AMENDMENT #A00003
MARCH 12, 2015

EXPAND CLINICS FOR PACT
DVA MEDICAL CENTER
IOWA CITY, IOWA

VA PROJECT #636-201

DRAWING NO.: 1-A2

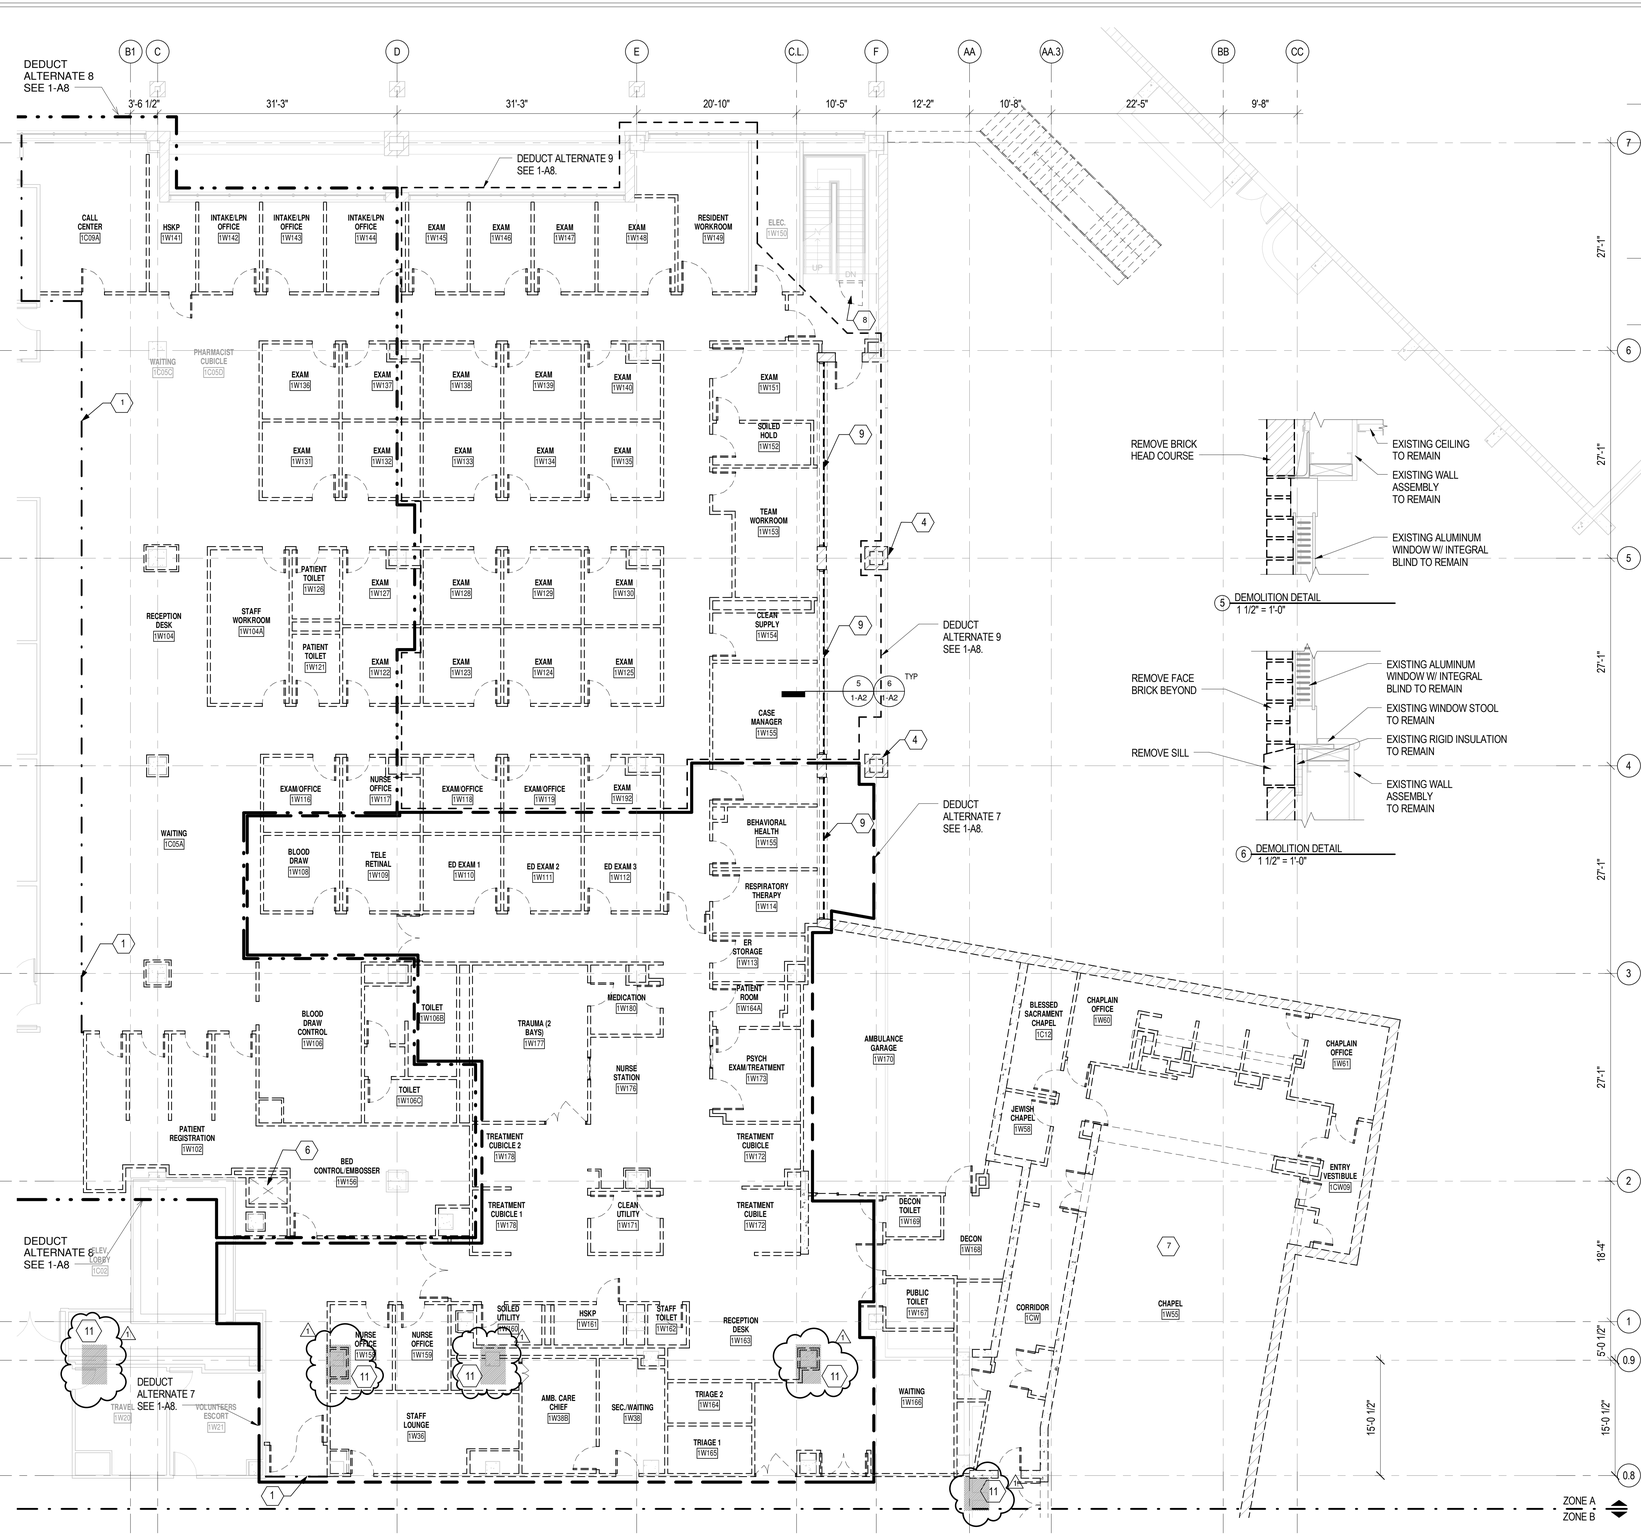
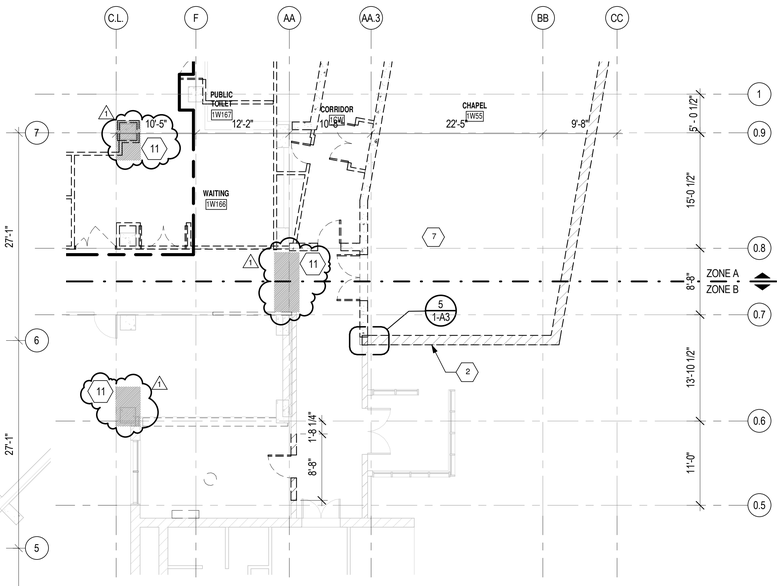
ITEM #5 SHEETS 1-A2, 1-A3, 1-A9 – **LOCATIONS FOR ABATEMENT**

A. Areas requiring abatement and areas possibly requiring abetment have been identified on the demolition drawings.

4 EXTERIOR DOOR AND RATED WALL DETAIL
1 1/2" = 1'-0"

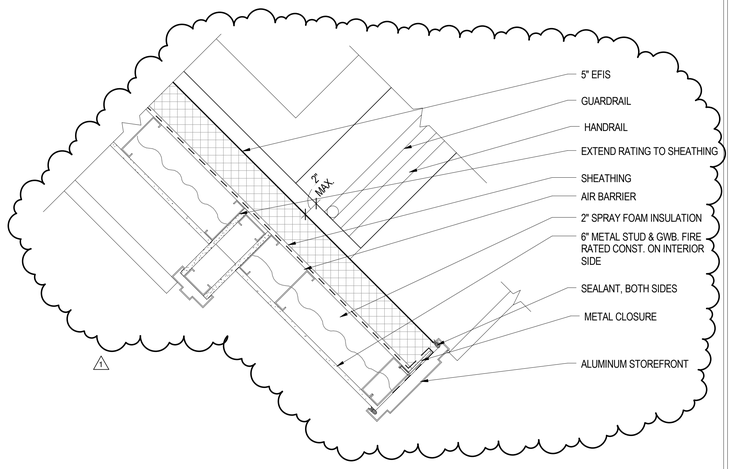
ITEM #6 SHEETS 1-G4, 1-A24, 1-A29 - **CLARIFICATION**

A. Exterior door 1CP06 shall be rated 45 min.

B. Exterior wall shall require 1-hour rated construction where indicated.
